Tesoro Refining & Marketing Company LLC

February 1, 2021

Re: Second Set of Comments on SCAQMD Revised Draft of Proposed Rule 1109.1 – Emissions of Oxides of Nitrogen from Petroleum Refineries and Related Industries
(Release Date: December 24, 2020)

Figure 1: Average and incremental cost-effectiveness analysis for Examples 1 and 2

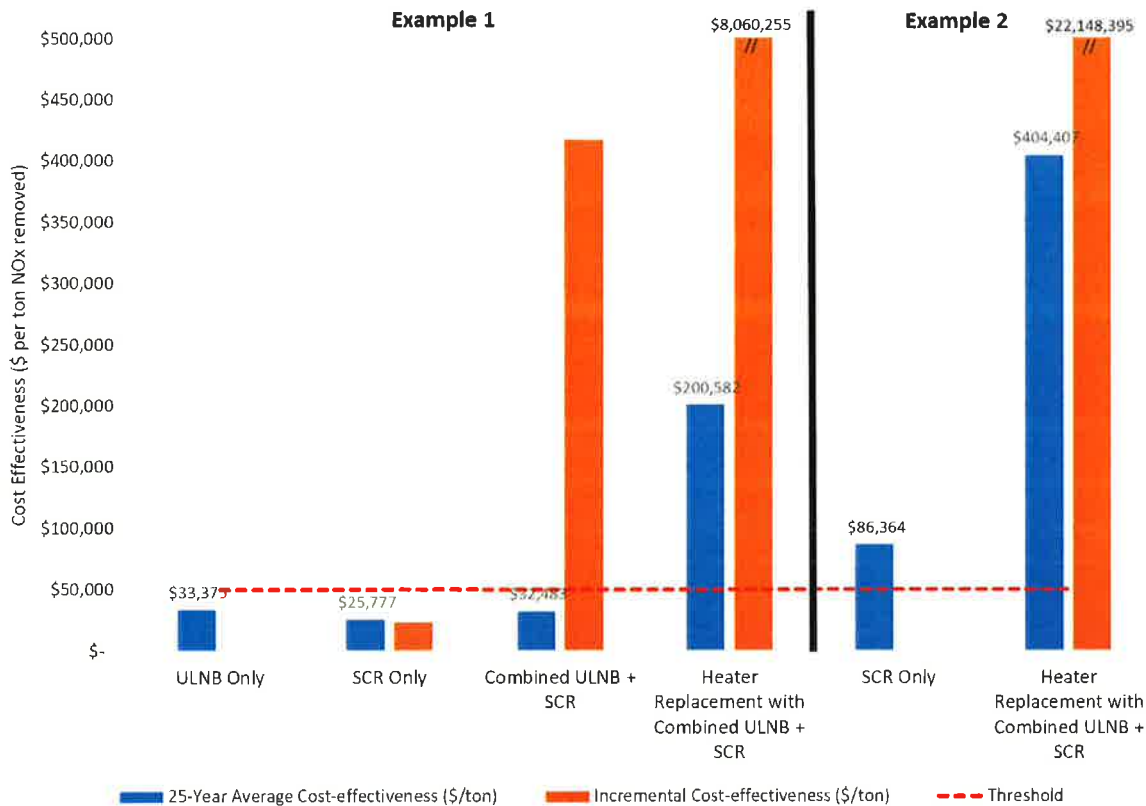
For Example 2, the average and incremental cost-effectiveness values show that both the SCR retrofit and the heater replacement control technology options are significantly above the threshold and thus economically infeasible.

Figure 1 displays the cost-effectiveness results for Examples 1 and 2 relative to the \$50,000 per ton cost-effectiveness threshold established by the SCAQMD Governing Board in the 2016 Air Quality Management Plan and to the relative control technology options on an incremental basis.⁸

These two examples are representative of many existing refinery heaters and boilers at LAR when considering the actuality of implementing such retrofit NOx controls and the associated NOx performance and cost. Coupling this with the reality that some heaters cannot be safely retrofitted with ULNB or have no physical space nearby for an SCR, the resulting cost-effectiveness inclusive of redesign, rebuild, or replacement of the heater and/or its associated process equipment, as well as the lost opportunity cost due to additional refinery downtime, far exceeds the \$50,000 per ton cost-effectiveness threshold. If SCAQMD is considering major equipment redesign and/or replacement to accommodate ULNB and/or SCR with a new heater design, these costs must be considered in the BARCT analysis.

Figure 2-2 Illustration of flame impingement on process heater tubes.

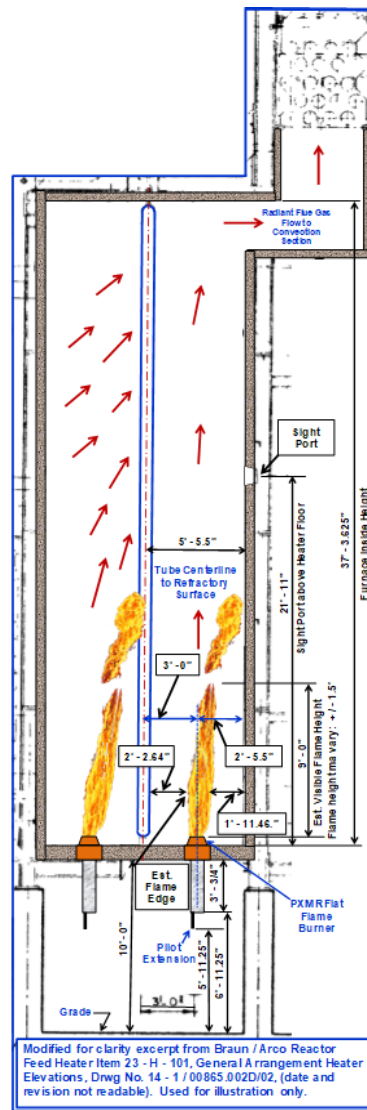
Figure 2-2 shows an example of flame impingement on process tubes.

In this design, the heater is a natural draft, double fired box heater with a vertical coil. The convection section is offset from the center of the box requiring the radiant section flue gas to go through the radiant tubes and to the convection section. Installing ULNBs with long flames could result in flame impingement, as shown. Further, long flames with certain heater geometries can cause flame impingement on the radiant arch (roof) refractory, the radiant roof tubes, or the convection shock tubes.

Such flame impingement, as described earlier in this document, could result in catastrophic failure. Therefore, flame impingement on the interior components of the heater must be avoided.

Figure 2-3 Burner firing towards a target wall.

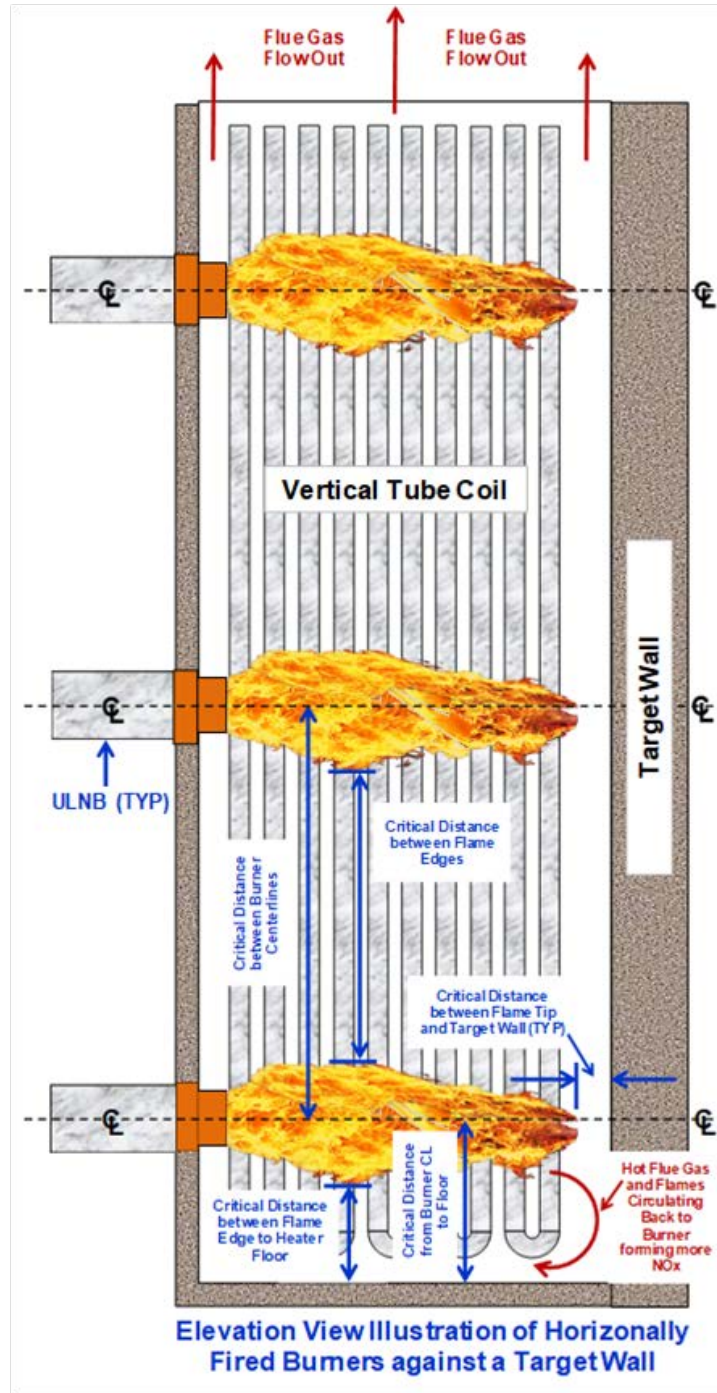
Figure 2-3 (also shown earlier as Figure 1-9) shows a burner firing towards a target wall.

Installing ULNBs with long flames may impact the target wall, spread out, impinge upon the tubes, and create additional NO_x by hot flue gas and flames near the floor circulating back to the burner.

Figure 2-4 CFD model of horizontal fired cabin heater.

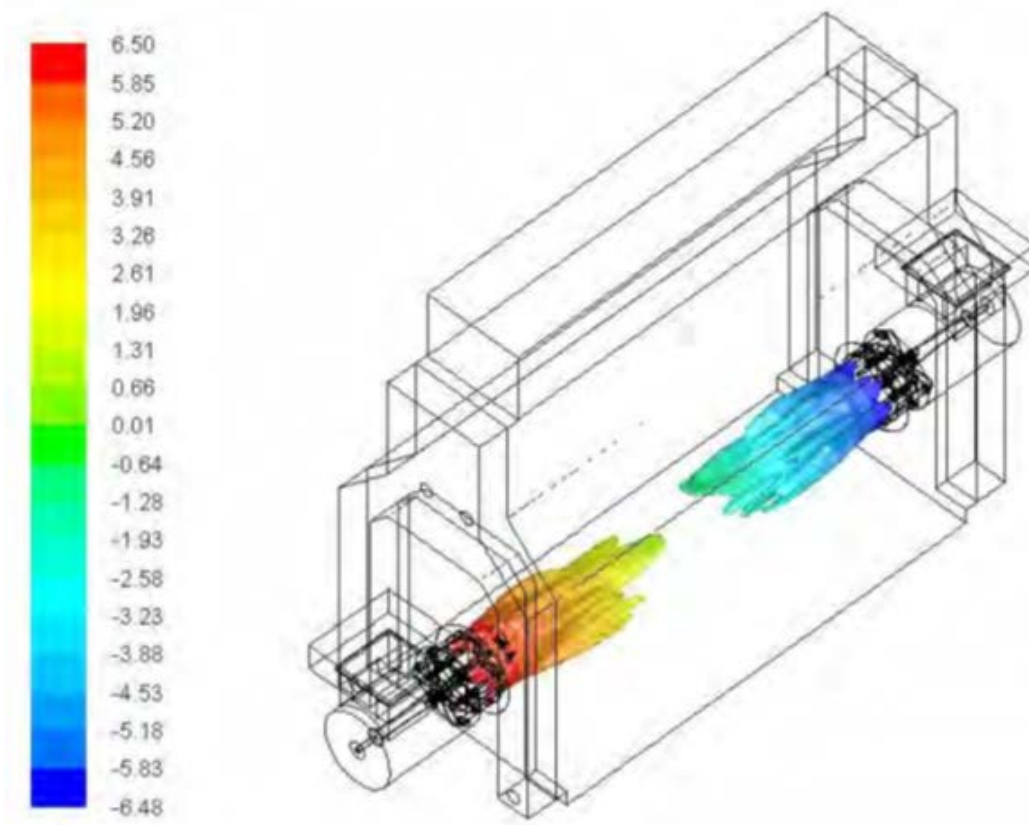
Another example is Figure 2-4 (shown earlier as Figure 1-8), which is a CFD model for a cabin heater with two horizontally opposed firing burners.

This example shows some space between the flame tips; however, some existing process heater designs may not have this spacing when ULNBs are retrofitted. If adequate space does not exist, then the flames will interact with either other, spread outward, and impinge on the tubes. Even with enough flame tip spacing between the burners, the radiant section internal currents may still pull the flames into the radiant section tubes.

Rule 1109.1 BARCT Categorization Example

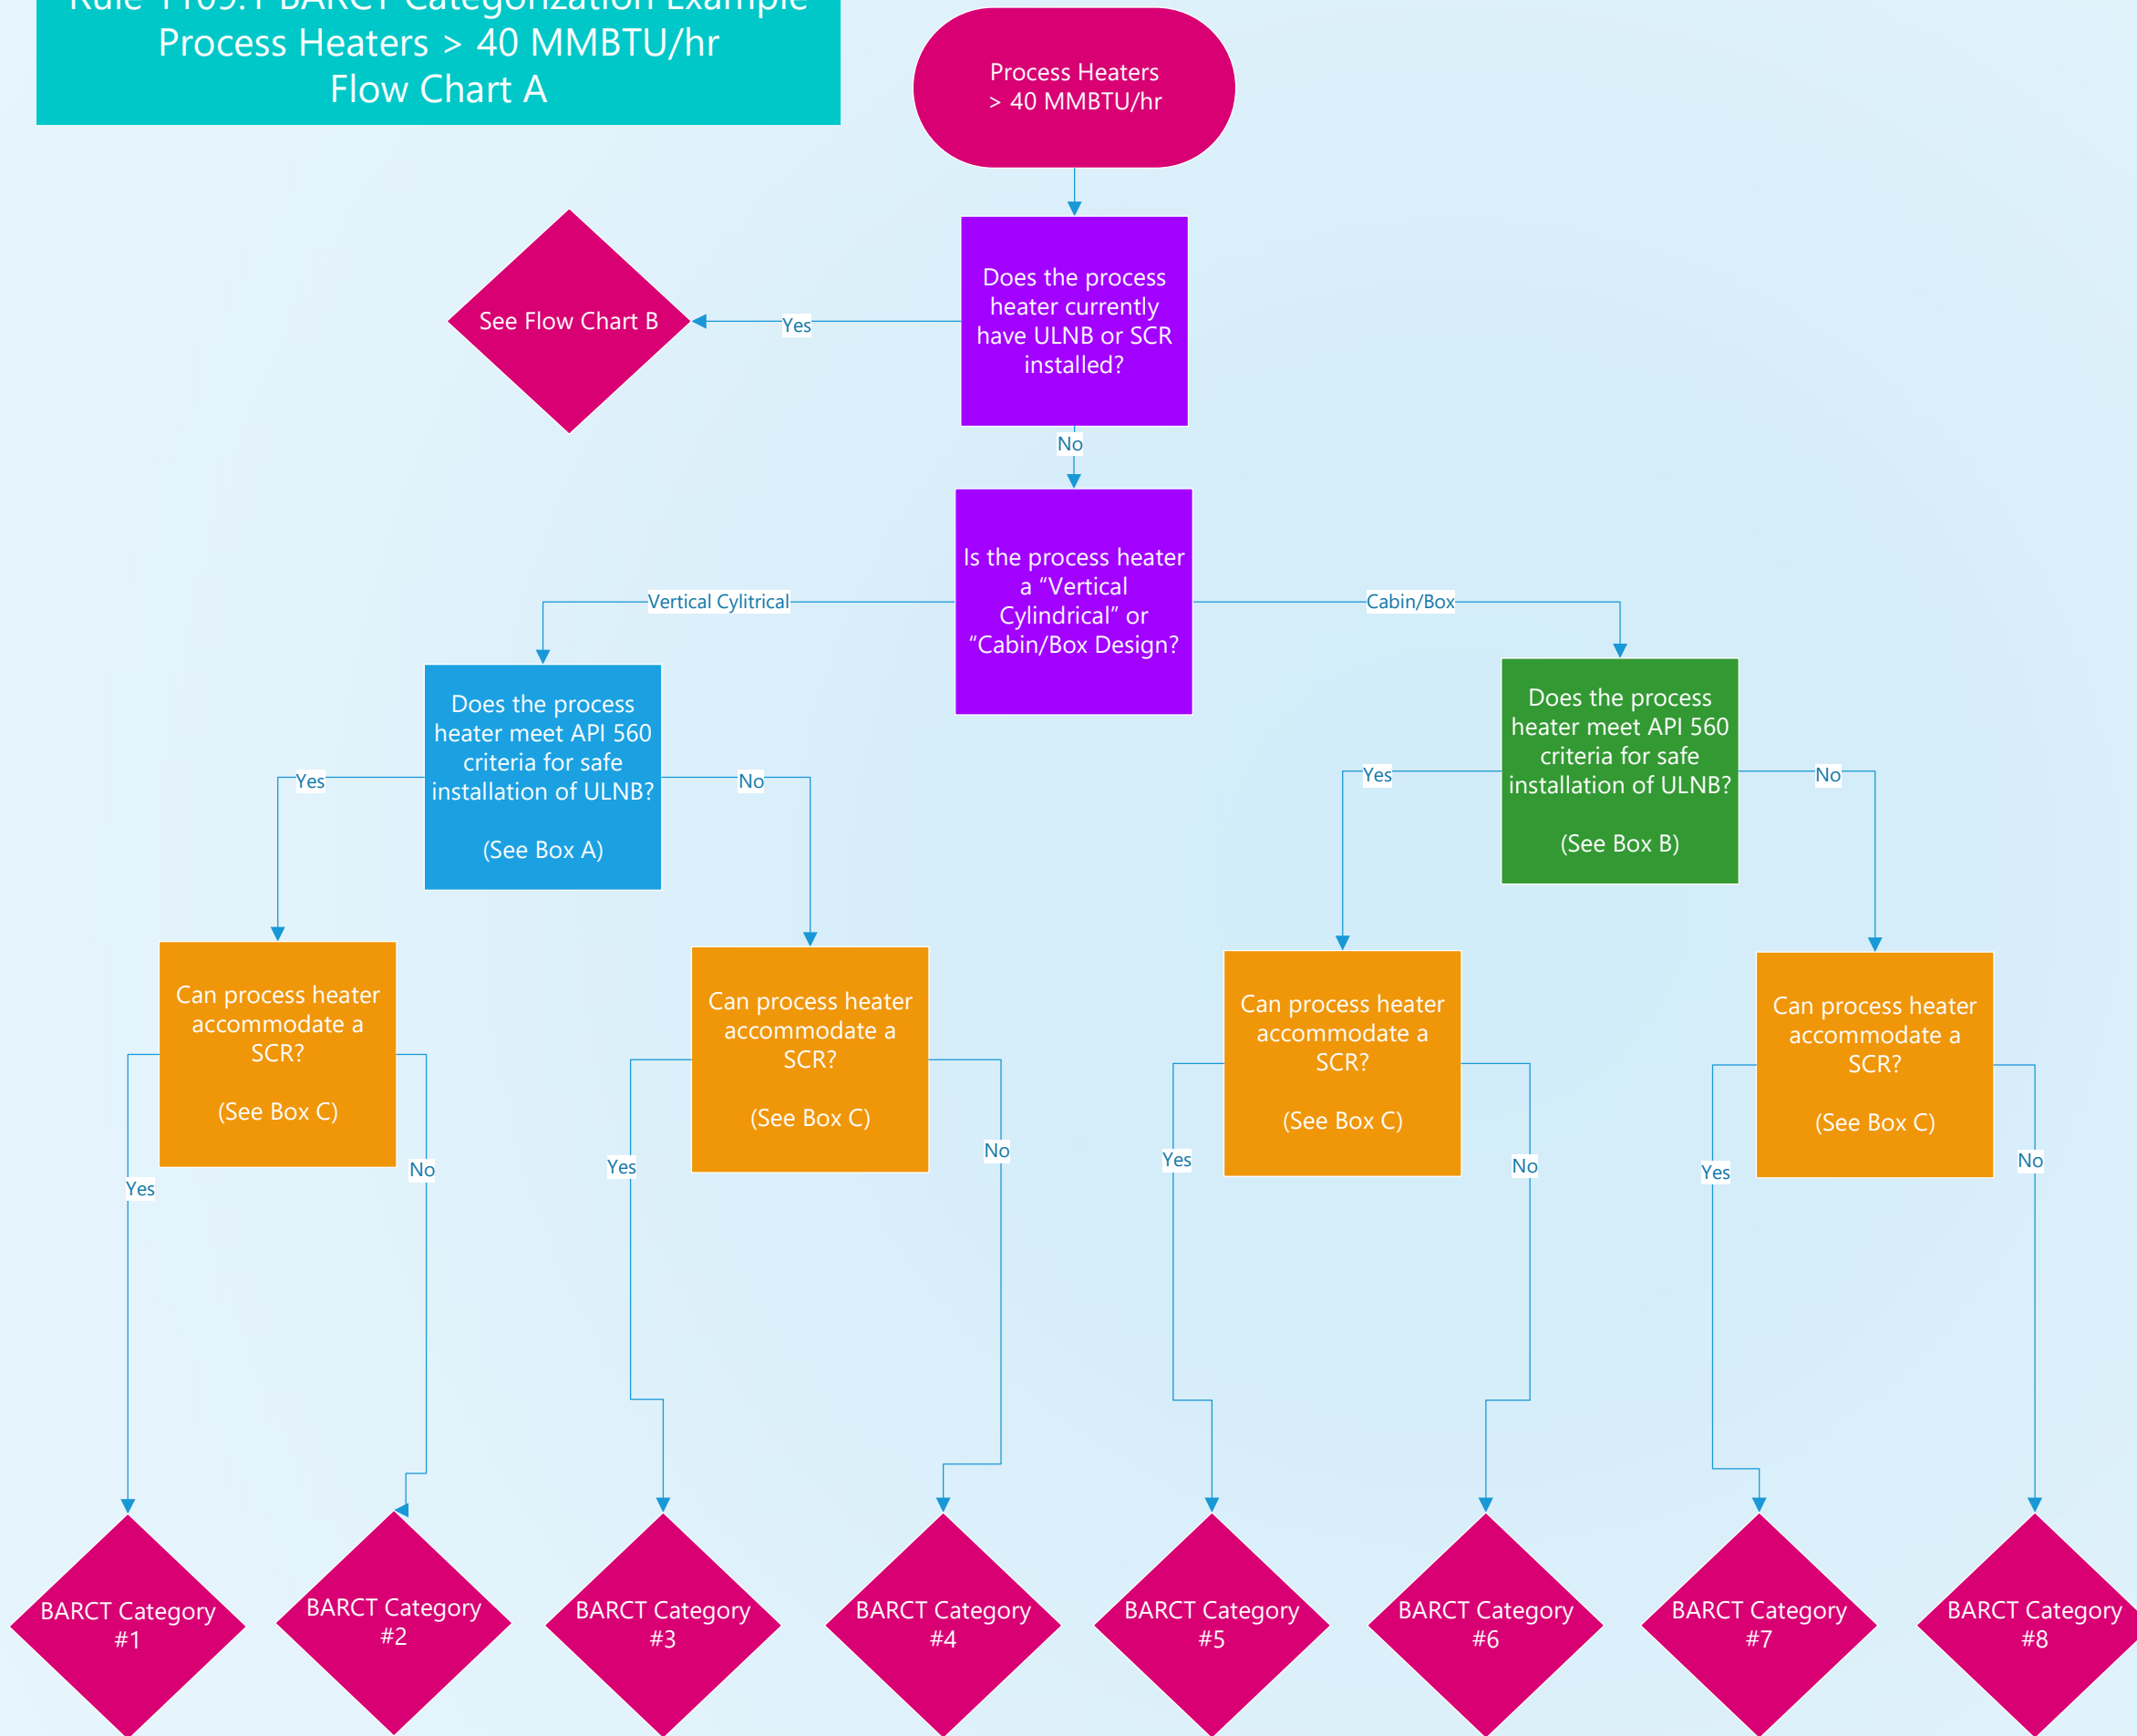
For reference, we have included a flowchart illustrating the steps SCAQMD should take when categorizing process heaters. Please refer to Attachment D. This example is not intended to be inclusive of all the key design criteria that must be considered for feasibility of ULNB and SCR at an existing heater.
